BUREAU OF ENGINEERING
DEPARTMENT OF PUBLIC WORKS
CITY AND COUNTY OF SAN FRANCISCO

DESIGNED: DATE:	APPROVED	SCALE:	CONTRACT 31	SPECIFICATION NO. 0872J
TP 10/05	SECTION MANAGER DATE:	1" = 10 feet	TRAFFIC SIGNAL MODIFICATIONS	DRAWING NO. E-13.1
DRAWN: DATE:	DEPUTY BUREAU MANAGER DATE:	SHEET OF SHEETS	OCEAN AVE & SAN JOSE AVE	FILE NO. 86,445
NL 10/05	CITY ENGINEER DATE:	42 OF 71		REV. NO. 6
CHECKED: DATE:				
BC 10/05

CONTRACT 31
TRAFFIC SIGNAL MODIFICATIONS
OCEAN AVE & SAN JOSE AVE
SCHEDULE

SPECIFICATION NO.
0872J
DRAWING NO.
E-13.2
FILE NO.
86,446
REV. NO.
6

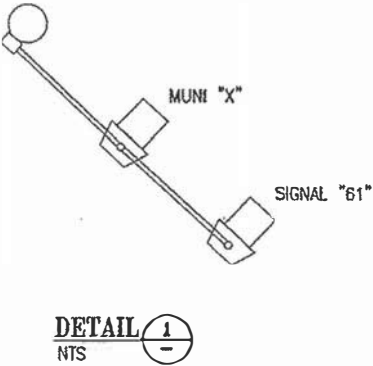
6	2/6/2020	Upgraded 41 and 62 to 12", added left angle visor to 42, and added right angle visor to 61 per SRC 2019-051	AL	BW
5	2/7/19	Per field check, upgraded 21 and 42 to 3S12"	AL	BW
4	12/15/17	SRC 2017-300: Converted "T" signals to red/white bars on Poles 3 & 5	TY	MV
3	11/13	PER FIELD: Converted crossbuck signals to red/white "T" on Poles 3 & 5. Upgraded signals 22, 61 & 81 to 12-inch.	TY	MV
2	7/25/06	per 7, add ops buttons, wiring, and stub-out poles	gd	bc
1	6/6/06	per 3, conduit modifications	gd	bc
NO.	DATE	DESCRIPTION	BY	APP.
TABLE OF REVISIONS				
CHECK WITH TRACING TO SEE IF YOU HAVE LATEST REVISION
